## 80% AFUE GAS FURNACE NEW LOOK

# CONVERTING R32 COMPLIANT FURNACE TO A 410A SYSTEM

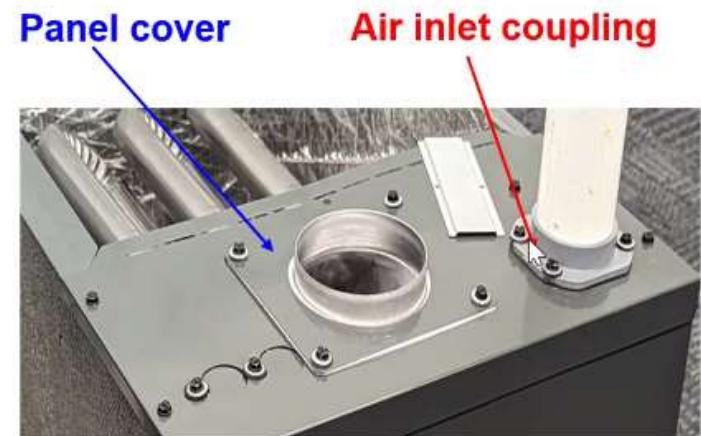
INSERT A 2" SCHEDULE 40 ELBOW AT  
COMBUSTION AIR INLET

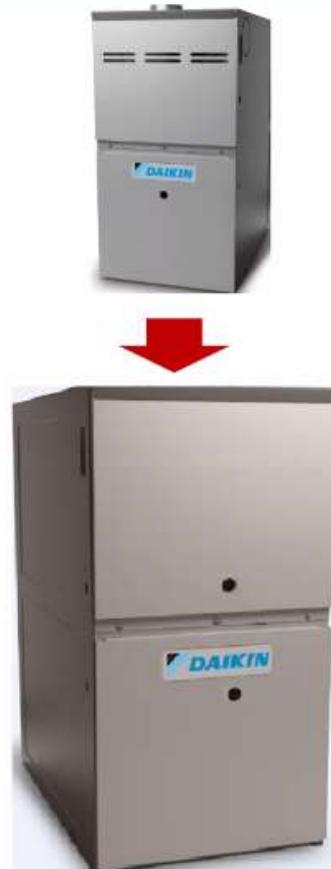
**From R32 furnace :** Press 3 buttons a total of 5 pushes to convert to R410A system furnace

**There are no dip switches.** The installer would need to press the left button two times to get to the A2L/R32 menu, press the middle button to enter the menu, press the left or right button to select 'No', and press the middle button to confirm the change. A total of 5 button pushes to turn of A2L/R32.
